IRRIGATION DETAILS

Details

ADDISON CIRCLE

PHASE 1

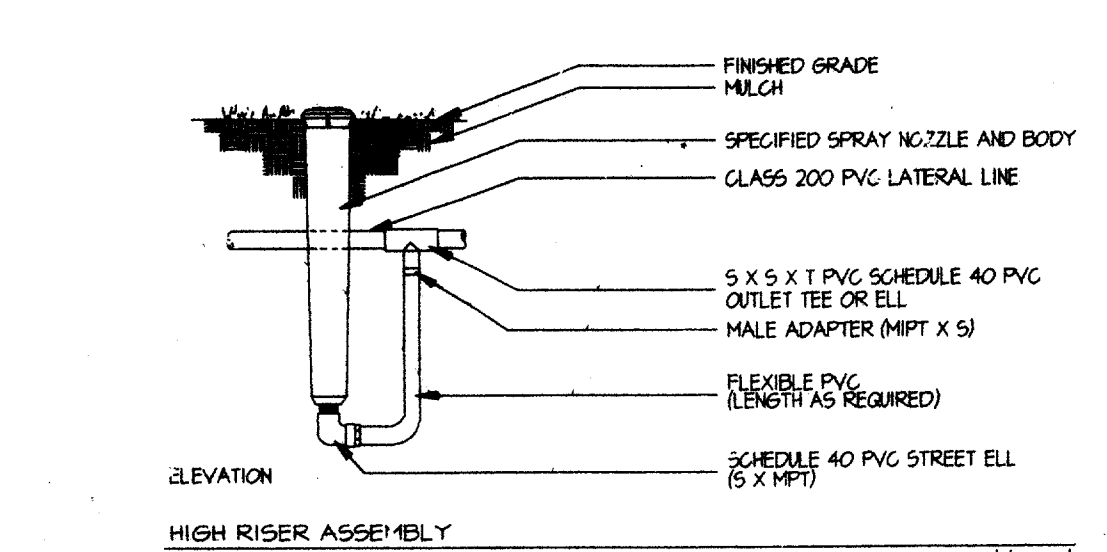
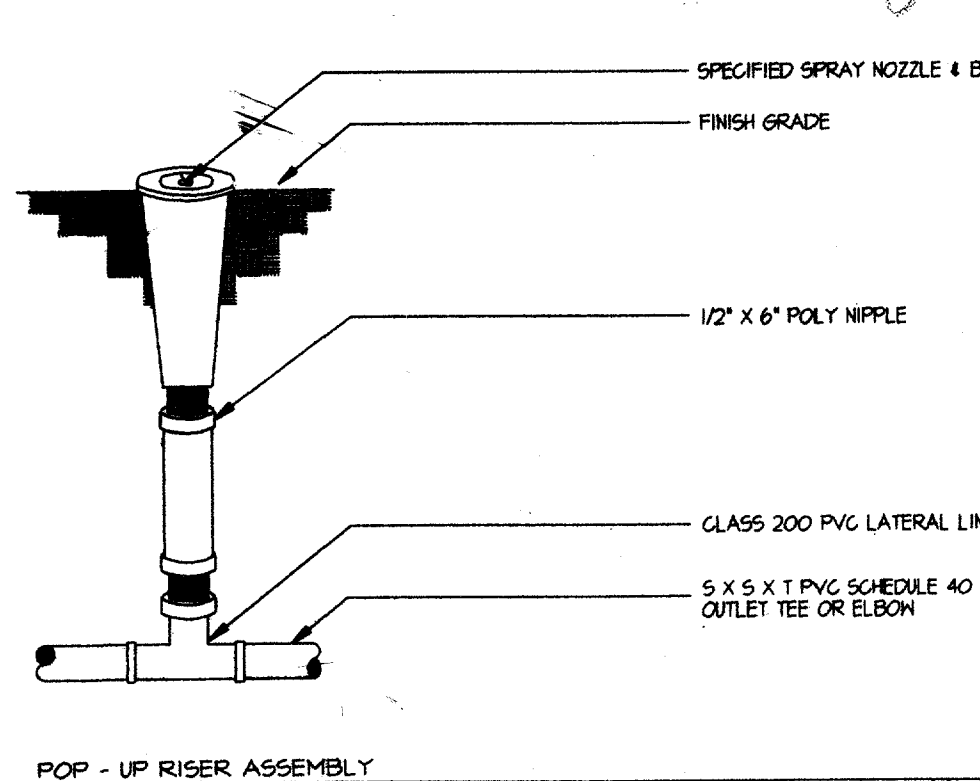
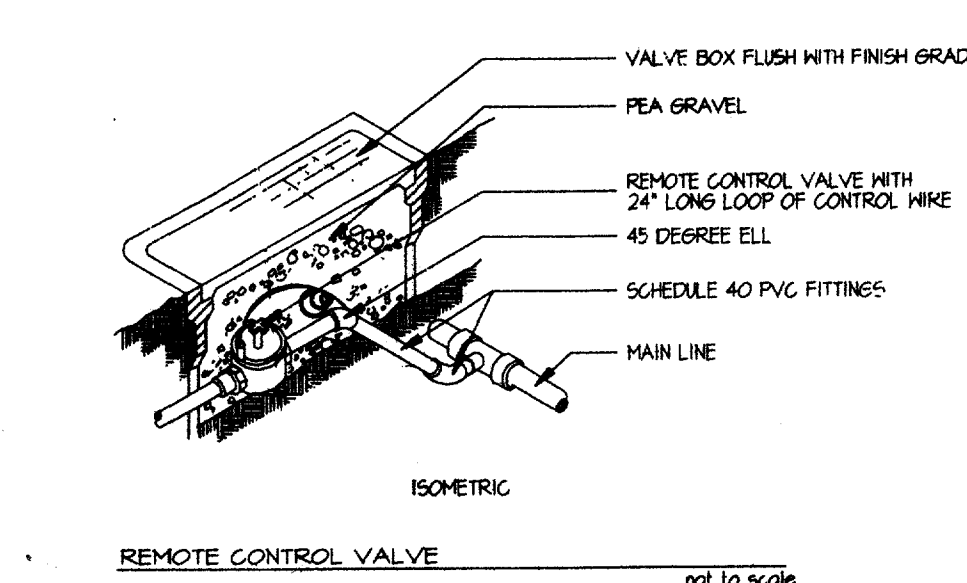
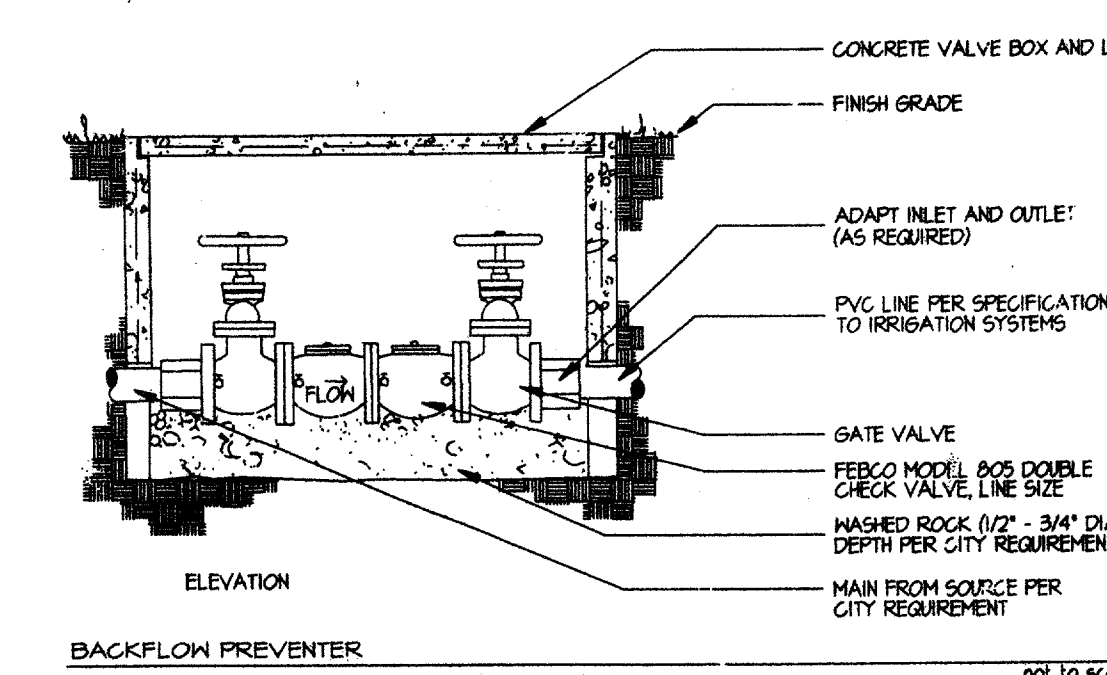
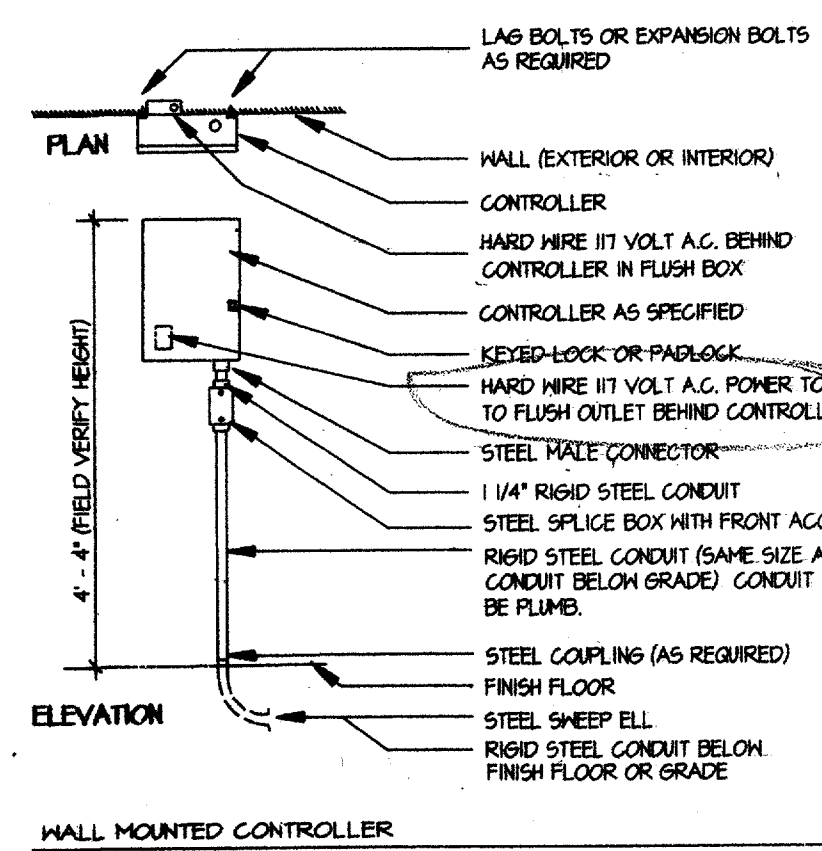
anytime?

The GC will decide who provides. Unless it's possible by owner, don't dictate

Addison spec. Prior to beginning work!

how?

conducted?
